## ACT Heritage Council

### **DEVELOPMENT APPLICATION TASKFORCE MINUTES**

### **Kingston Section 49 Master Plan**

### **Kingston Section 49 Master Plan and Statement of Heritage Effects**

Figure 3 Kingston Section 49 masterplan.  
 Source: 'Kingston S49 Masterplan' (July 2013), p. 10.

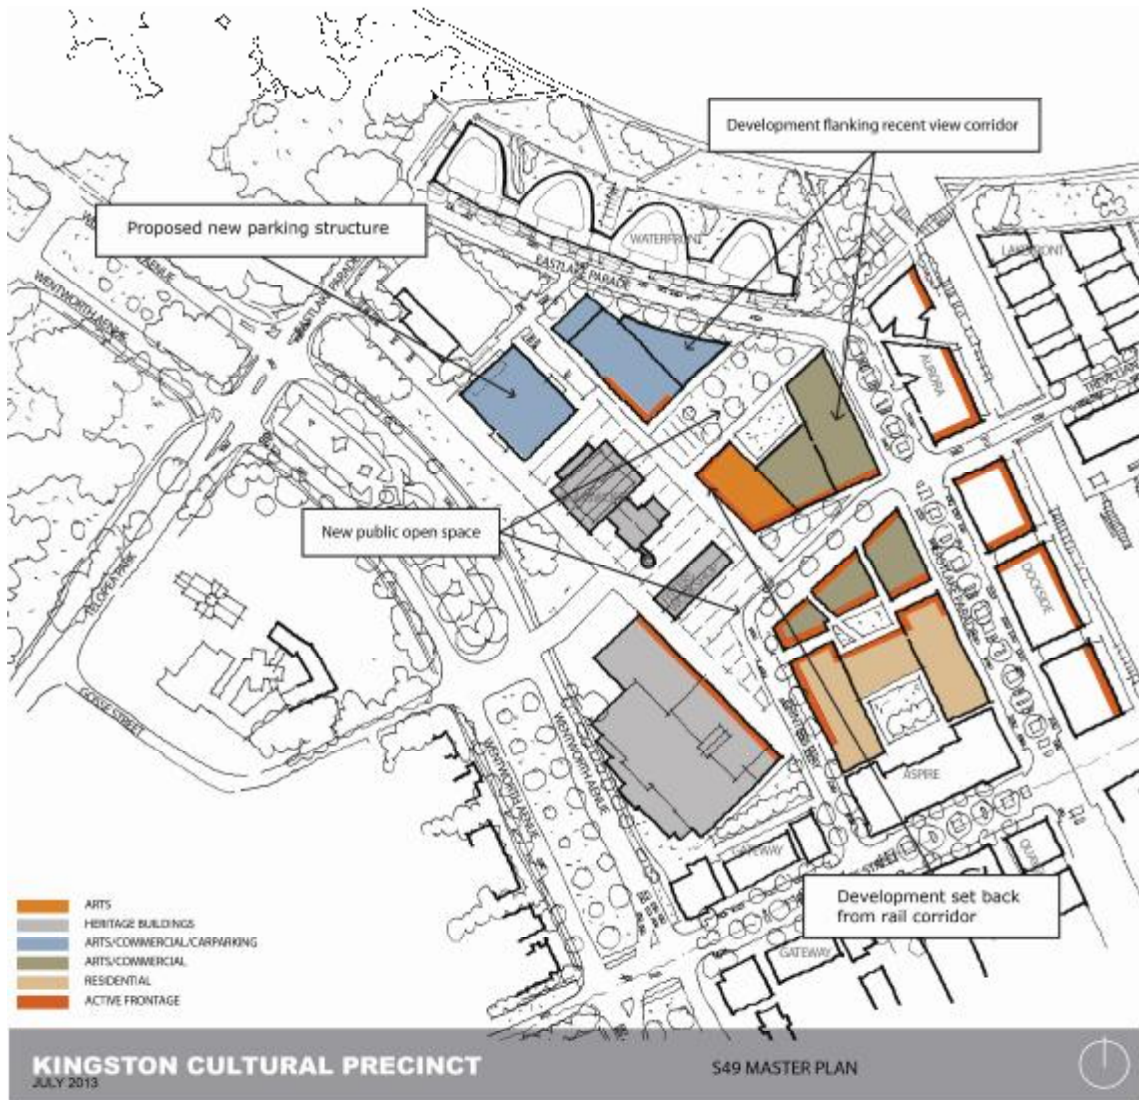
New built form is proposed to the north-west, north-east and south-east of Kingston Section 49 (Figure 3).

A multi-level parking structure is proposed to the north-west of the Power House. This site is within the zone of lesser heritage sensitivity, as identified in the Heritage Strategy (Section 6.4). There is a requirement for the parking structure to accommodate 480 spaces. This is an outcome of the LDA's commitment to replacing the existing 480 surface car parking spaces at Kingston Section 49 to support the Kingston Arts Precinct. The commitment is in accordance with the requirements of the Territory Plan and the Parking and Vehicular Access General Code.<sup>3</sup>

Figure 4 Concept sketch of the proposed parking structure, viewed from the south-west.

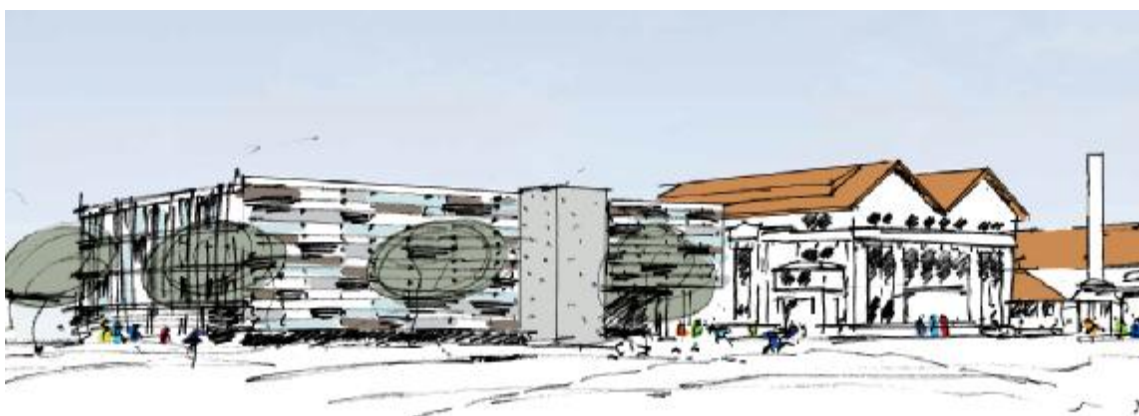
The concept sketches indicate that the upper level of the parking structure is aligned with the underside of the Power House eaves (RL 573.1), which is approximately 13m above ground level (Figure 4). The sketches also indicate stair/lift cores projecting from the north-east and south-west elevations. These assist in breaking down the building's mass. There is an undercroft to the south-east of the parking structure, at the interface with the Power House. Retail tenancies may be located within the undercroft.

No details have been provided regarding the materials of the facades. However, it is understood that the intention is to provide a neutral cladding system, to minimise the visual impact of the parking structure as a foreground element in views of the Power House from the north and north-west.

Figure 5 Sequential development plan of the former Transport Depot, Kingston. The 'Northern Annex' is indicated.  
Source: Former Transport Depot CMP, Philip Leeson Architects (2011), p. 16.

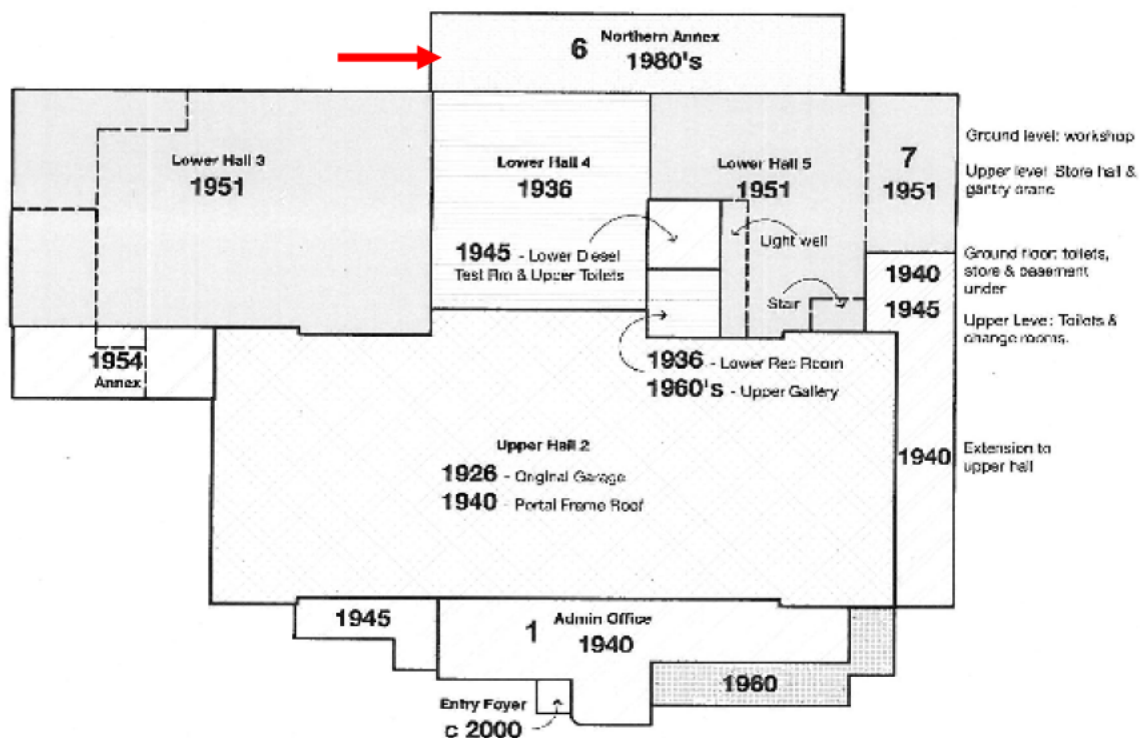
Also proposed for demolition is the northern annex to the Transport Depot (Figure 5). The northern annex (1980s) is built over the alignment of the south-west rail siding alignment.

The location of the northern annex on the alignment of the south-east rail siding inhibits an understanding of the rail sidings as historically open spaces that provided the core planning determinant in the development of the area.

Figure 3 Concept sketch for structured car park between the Power House and the '1948 Switch Room' (2012).  
Source: Cox Architecture.

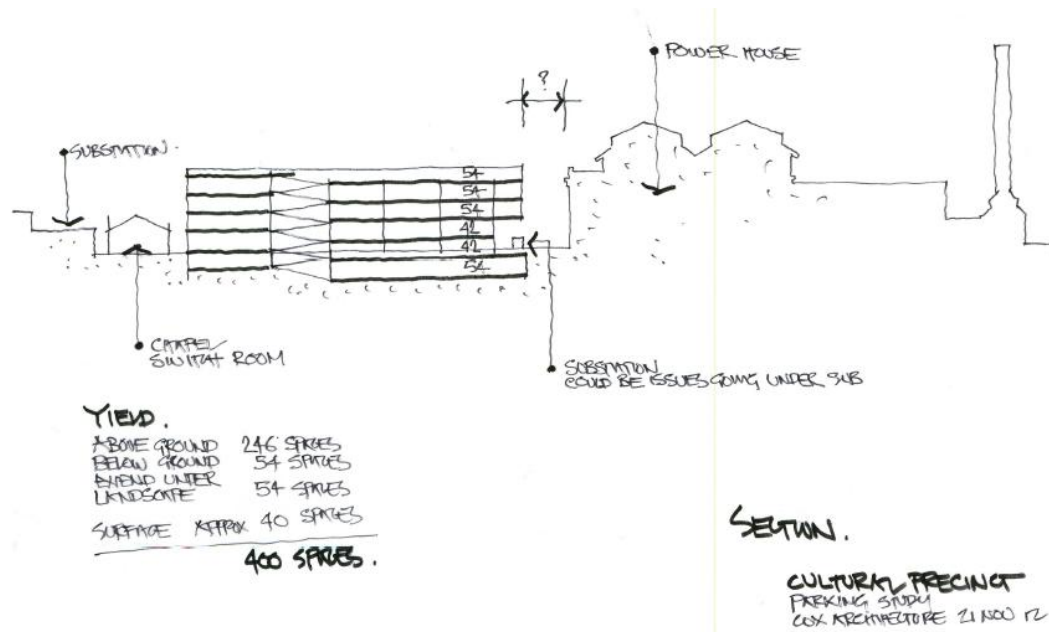
Consideration was also given to establishing what parking capacity could be achieved on the preferred site without requiring demolition of the '1948 Switch Room'. Concepts prepared by Cox Architecture in 2012 (Figure 3) indicated that approximately 400 spaces could be

accommodated between the Power House and '1948 Switch Room' without encroaching into the rail alignments. This option was not pursued due to the proximity of the structured car park to both the Power House and '1948 Switch Room' and the consequent impacts on views to both buildings.
